**Integrated Electric Resource and  
Master Plan Task Force  
Report to Columbia City Council  
November 2021**

# DRAFT REPORT

The attached report covers highlights, observations and findings made by the Task Force that are derived from the Siemens Industry Inc. (consultant) IRP and MP reports that were completed earlier this fall. Our report is not intended to replace the consultant's report, but rather to provide a perspective on selected topics from that report which the Task Force has deemed worthy of special notice. We do not agree with all the findings presented by Siemens and have pointed those disagreements out. Nor do we have unanimous agreement within the Task Force on every observation and recommendation made, and have introduced minority opinions to help Council understand those divides. Overall, this Task Force report is intended to inform the Council of our thinking regarding these critical issues.

Figure ES-2: A Comparison of Cost-Benefit Analyses of Solar Energy by Study and Category.

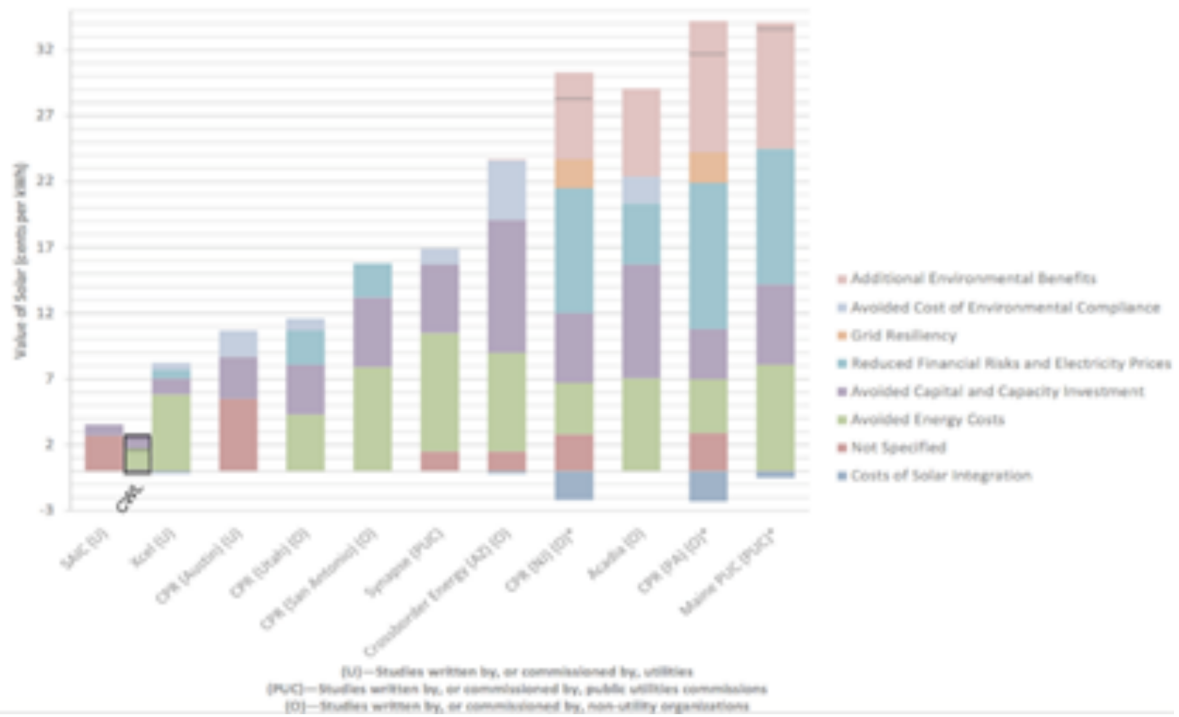
- **Task Force recommends Council not rely on this value of solar study** to represent the total value of solar in Columbia
- Task Force recommends a follow-up study be conducted to include a wider set of input variables to reflect the interests of the community, primarily environmental and societal valuations.
- Task Force expectations were that the study would include environmental and societal values. These were not conveyed to the consultant’s sub-contractor. As a result, the value for solar in

Columbia was ranked at the lowest end compared to 11 other Values of Solar, in a 2016 study (figures 1&2 in Appendix A). The consultant's report is not a comprehensive representation of values for solar in Columbia.

## Appendix B Task Force Members Poll on Transmission Options and Graphs from Siemens Analysis

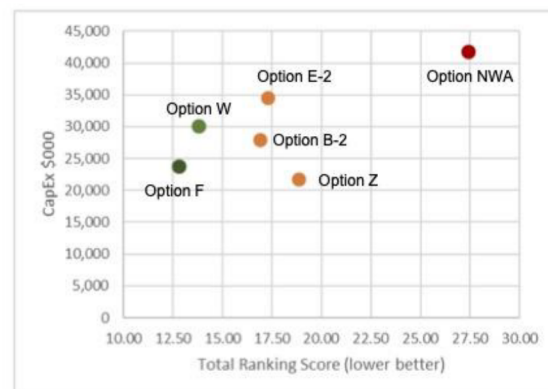
- Considering Cost and Ranking (see figure to the right) we observe that Option F seems to be the preferred with a capital level similar to Option Z but much better performance. It requires the CEC to address AECI overloads.
- Option Z is the least cost, but it requires the CEC, has high loadings and some overloads in AECI system under 2030 and High Load are not resolved and high
- Option W and Option B-2 have similar cost, but option W has much better performance and relies much less on the CEC to address AECI overloads.
- In summary and based on the above it is our opinion that CWL should pursue two parallel paths for the development of Option F and Option W.
- Option F has risk as it depends on agreements with Ameren and Option W requires expanding a transmission corridor in an urban setting, which has risks.
